n. 2 Reveley Square

PLAN

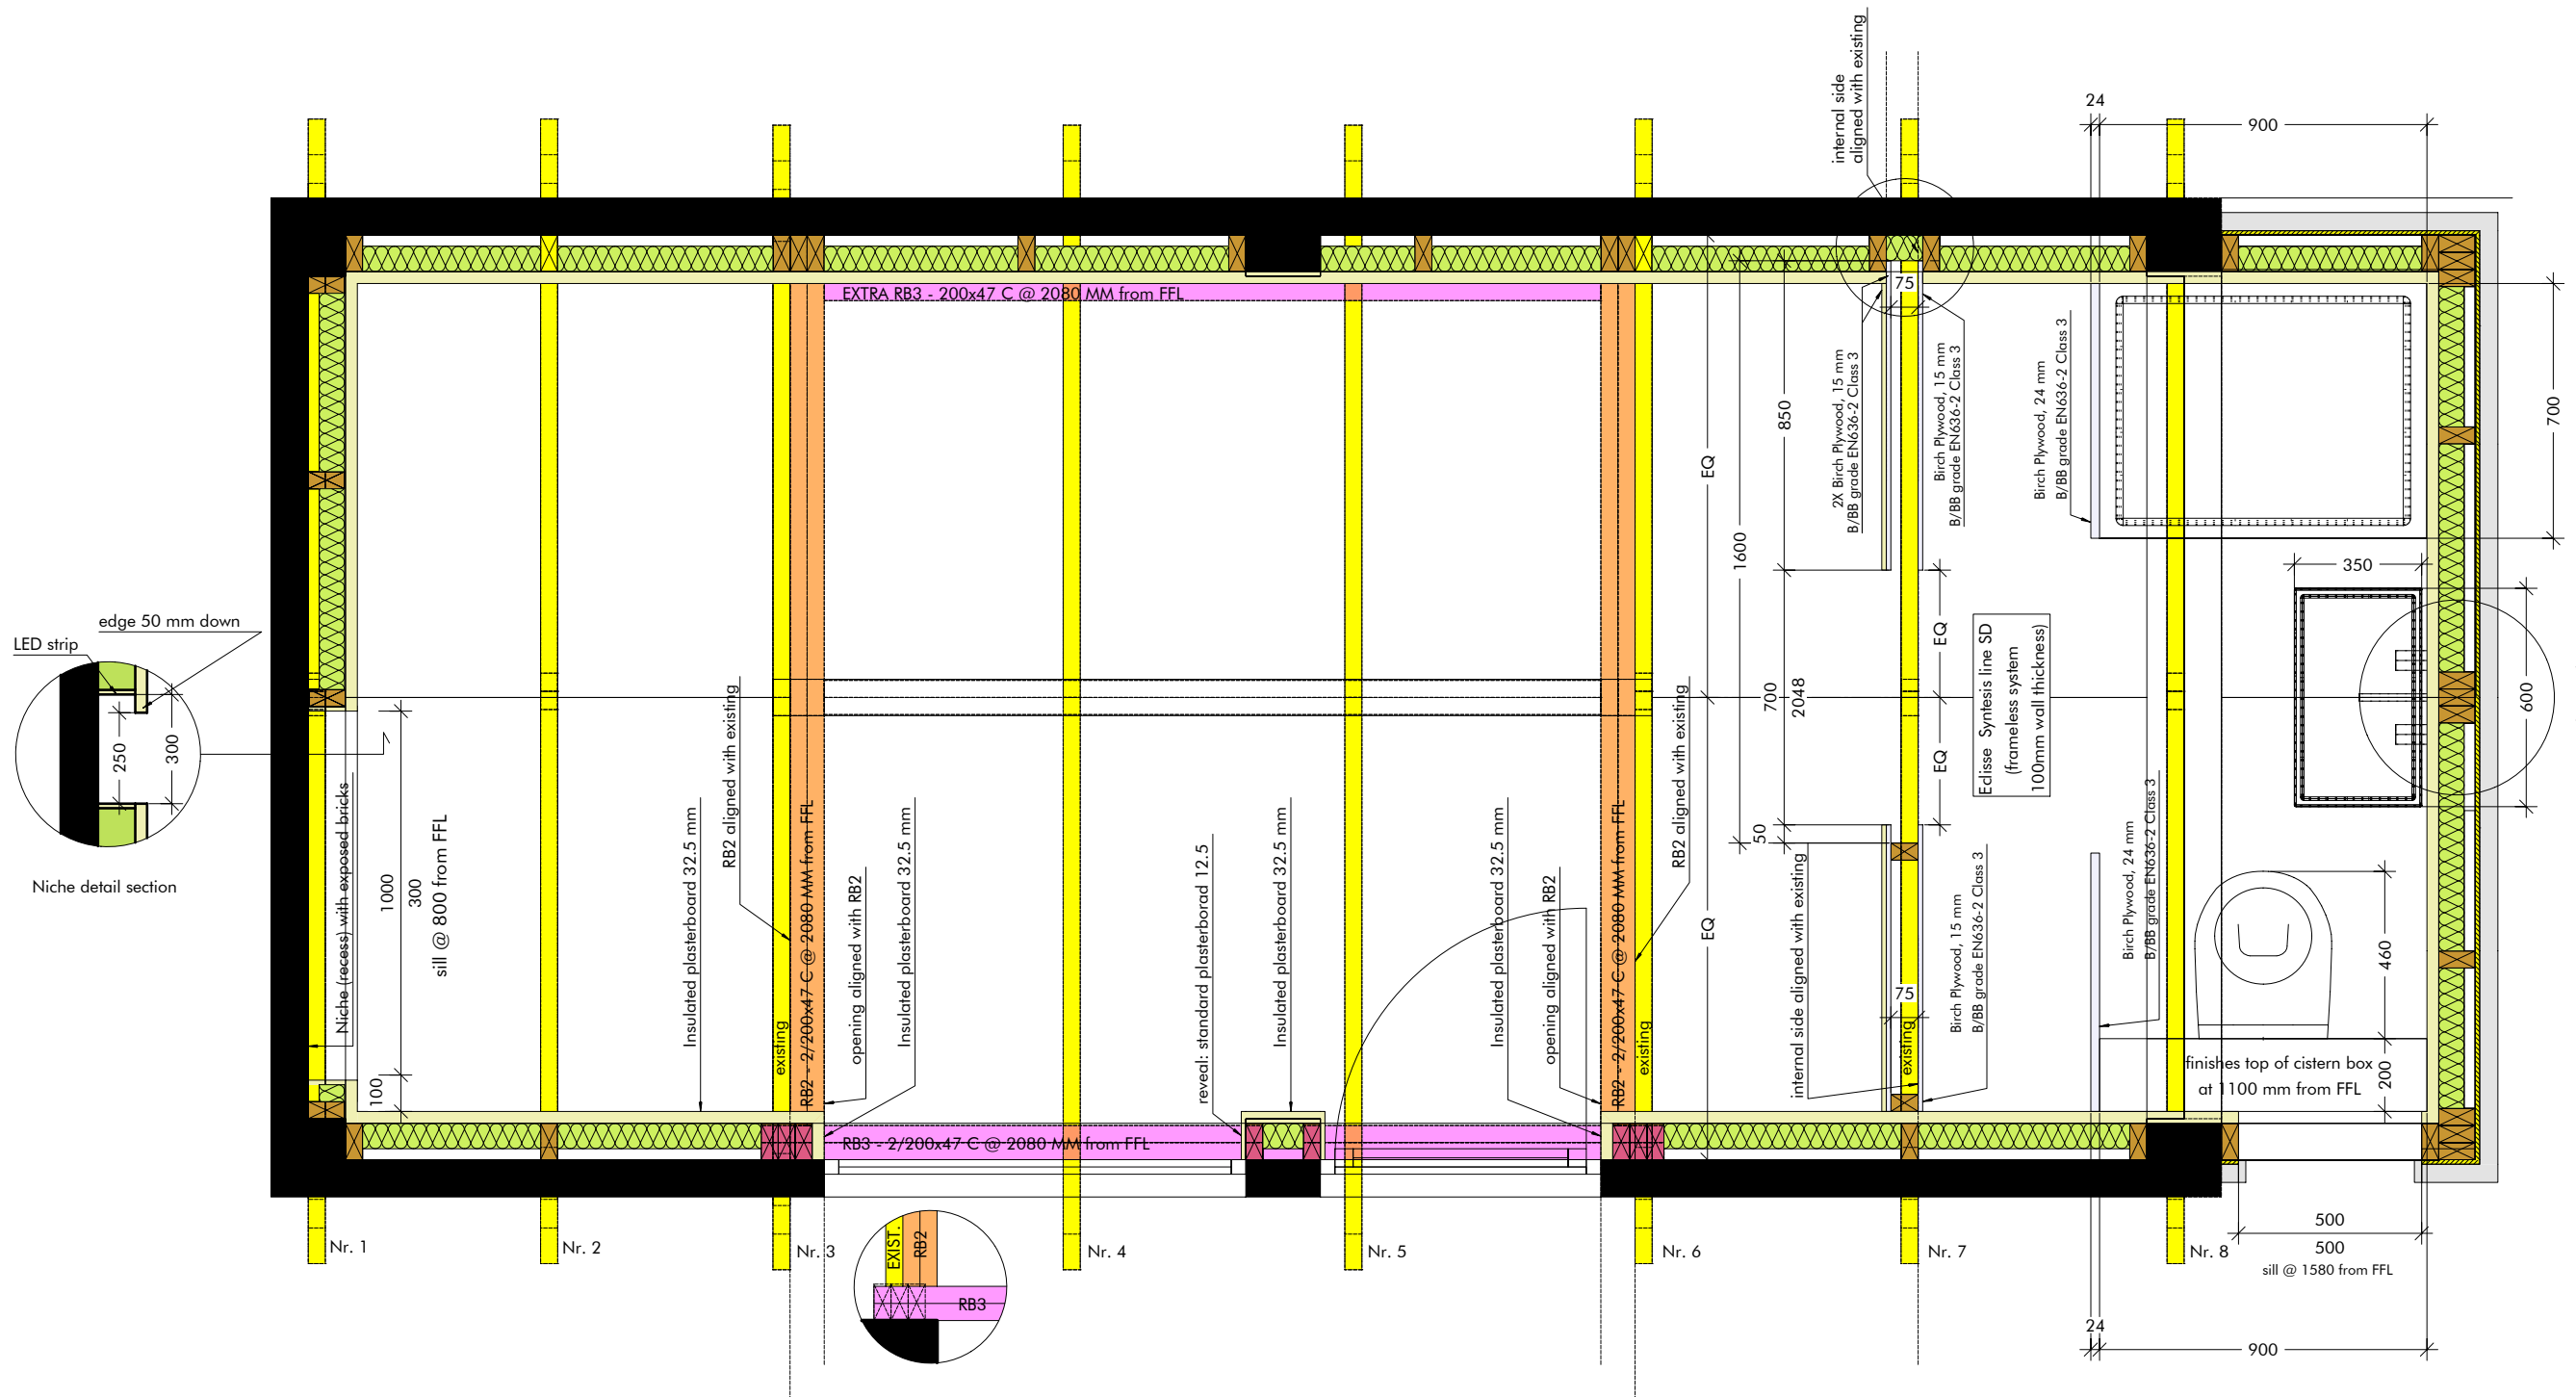
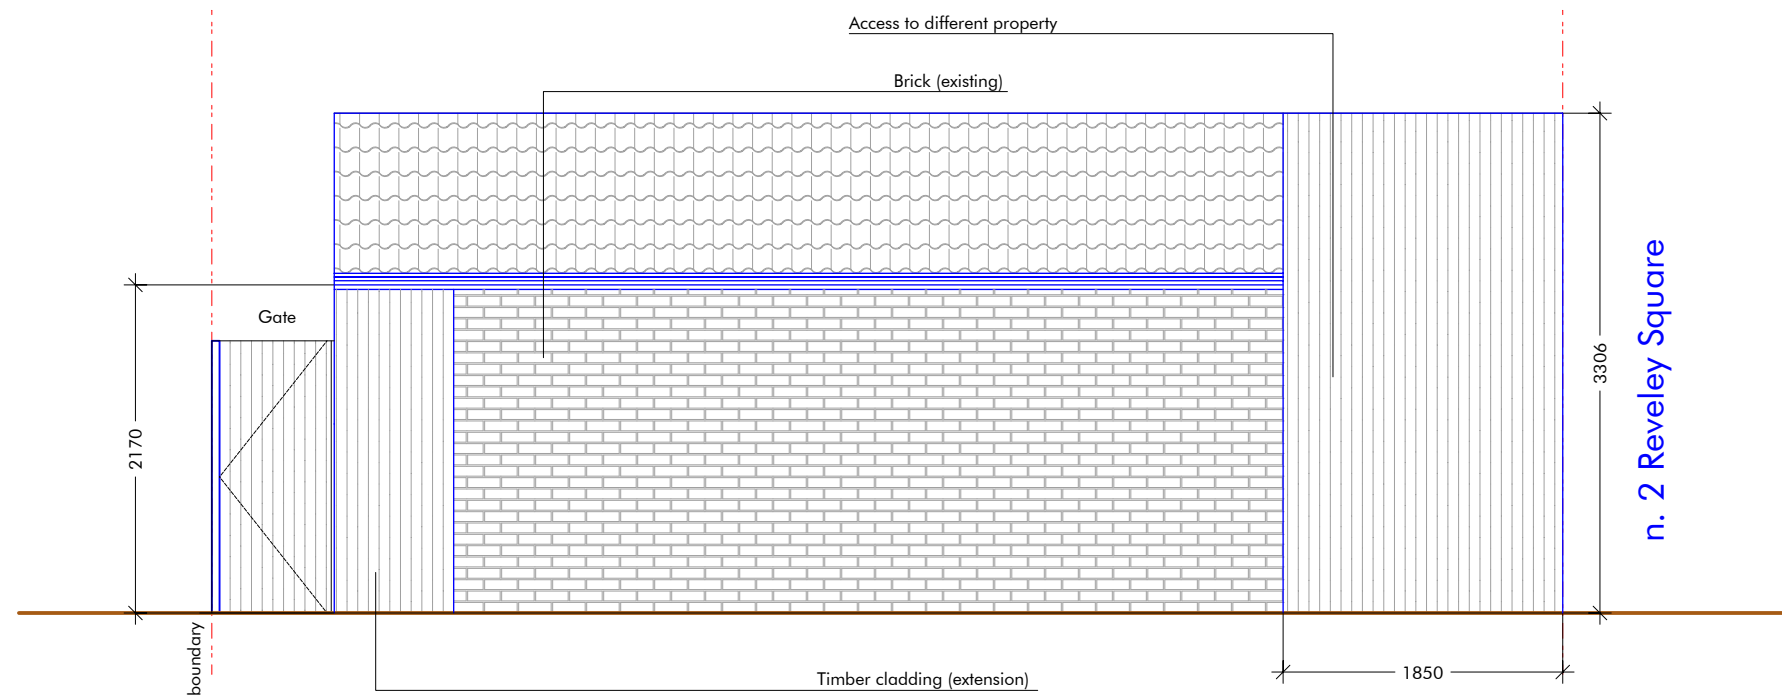
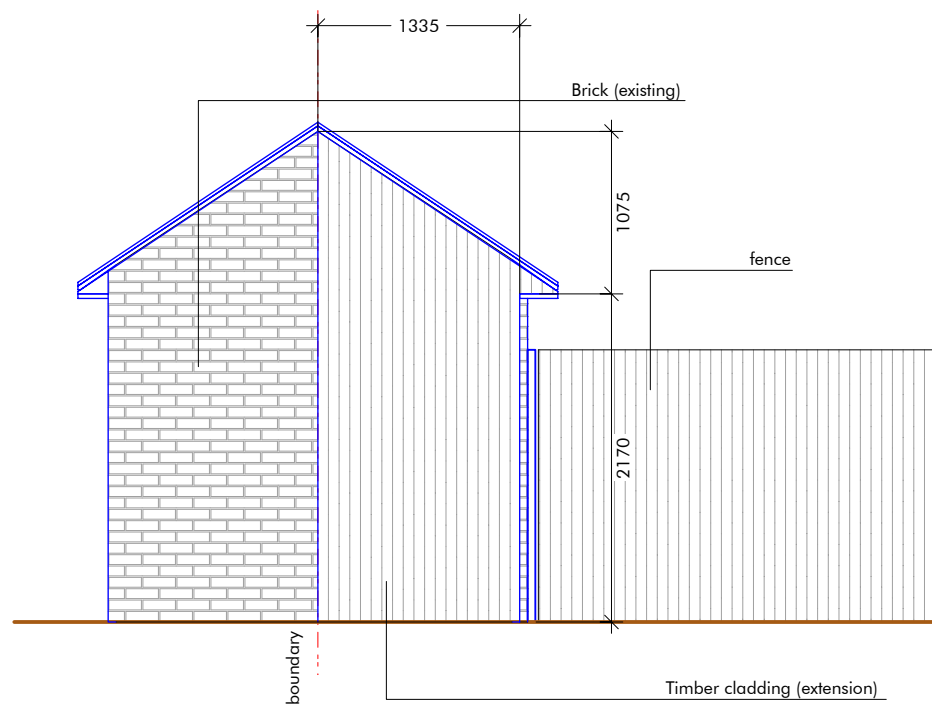
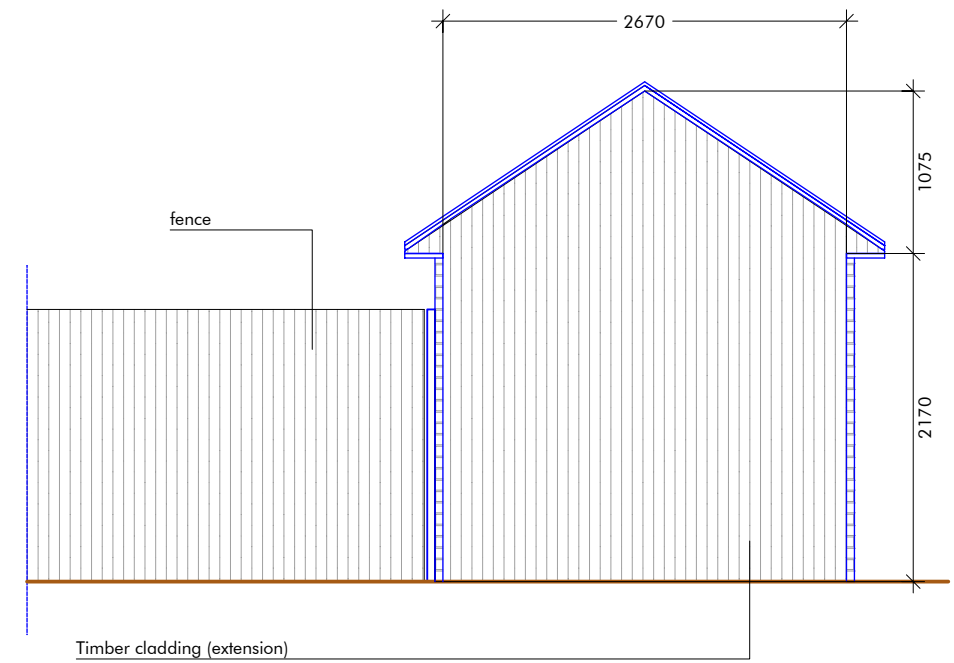
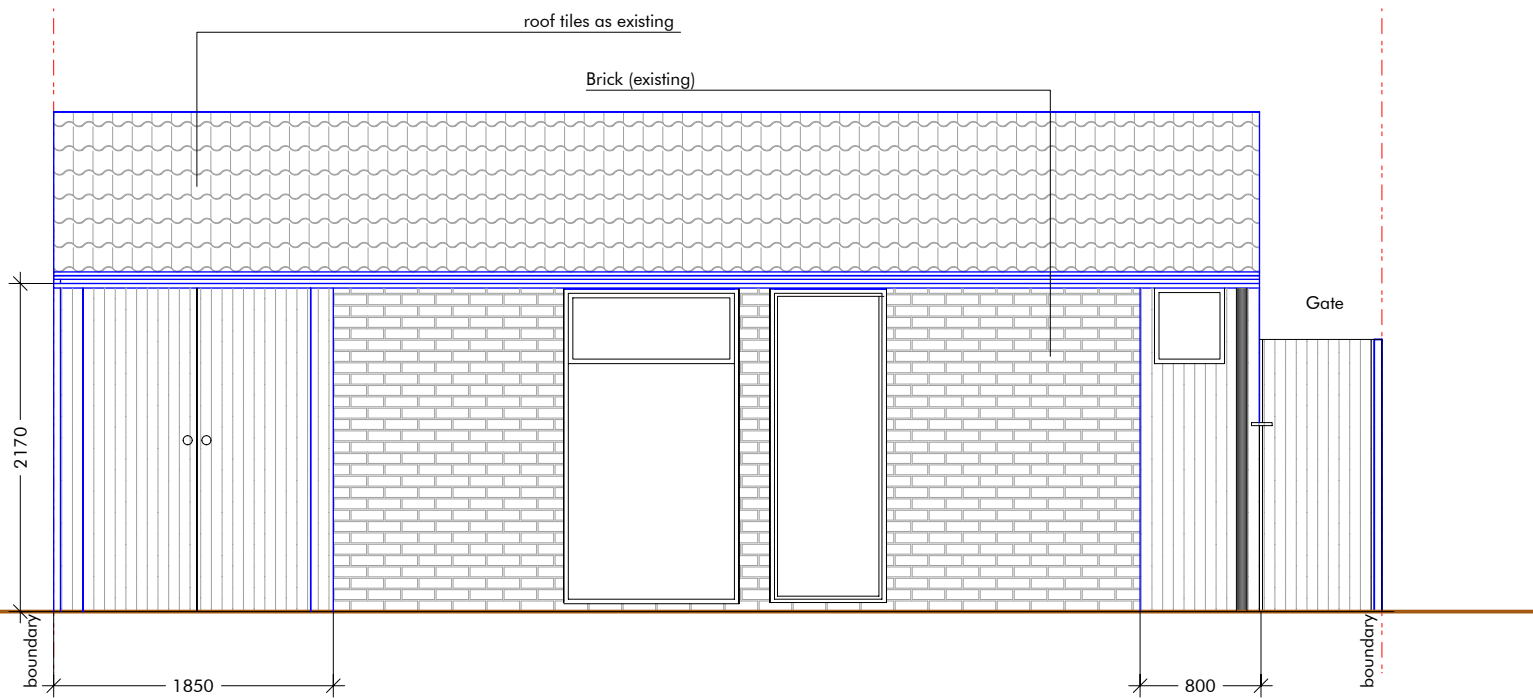
PLEASE NOTE THAT
WITH THE CURRENT POSITION
OF THE TRIPLE STUDS
THERE IS NO ROOM TO RUN
PIPES FEEDING WATER AND DRAINAGE
